Ousedale Creek Koala Underpass (formerly Brian Road Intersection Upgrade)

REF submissions report

June 2025

Figure 3-1 Typical box culvert underpass design

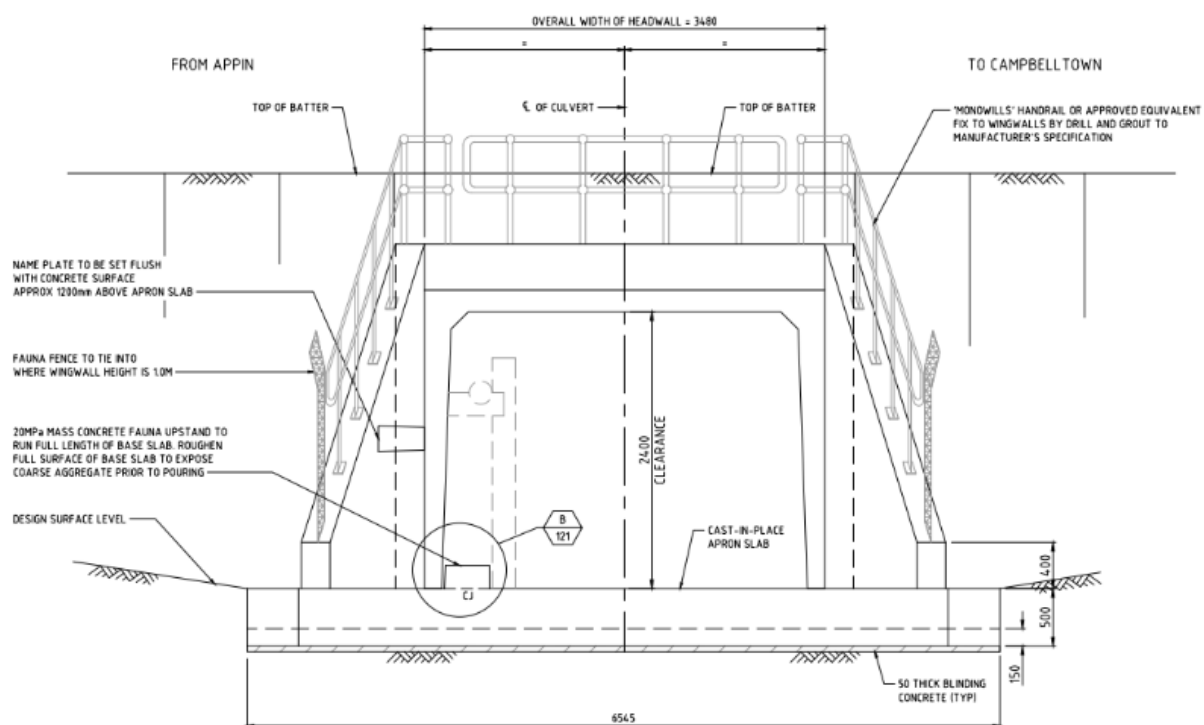
To address feedback around the efficacy of the proposed round reinforced concrete pipe underpass (2.4m in diameter and 36m in length), the underpass at Ousedale Creek has been redesigned to incorporate a reinforced concrete box culvert 3m wide, 2.4m high and about 36m long. An example of a box culvert underpass is shown in Figure 3-1. The design of the underpass would be confirmed during detailed design.

Changes have also been made to the previously narrow 'channelised' drainage swale on the western side of the underpass. This has been widened to improve the likelihood of a koala finding the underpass and to avoid a steep batter on the southern side that could discourage koala access.

In response to submissions, the underpass design as exhibited has been changed. The underpass would now be a reinforced concrete box culvert 3m wide, 2.4m high and about 36m long. The revised box culvert design is sufficient for koalas, macropods, and other terrestrial native wildlife. Monitoring of other similar-sized underpasses has consistently demonstrated use by a range of native species. For more information refer to the fauna connectivity tab at [Biodiversity | Transport for NSW](#). The previously narrow channelised drainage swale on the western side of the culvert has also been widened and opened to better funnel koalas into the underpass.
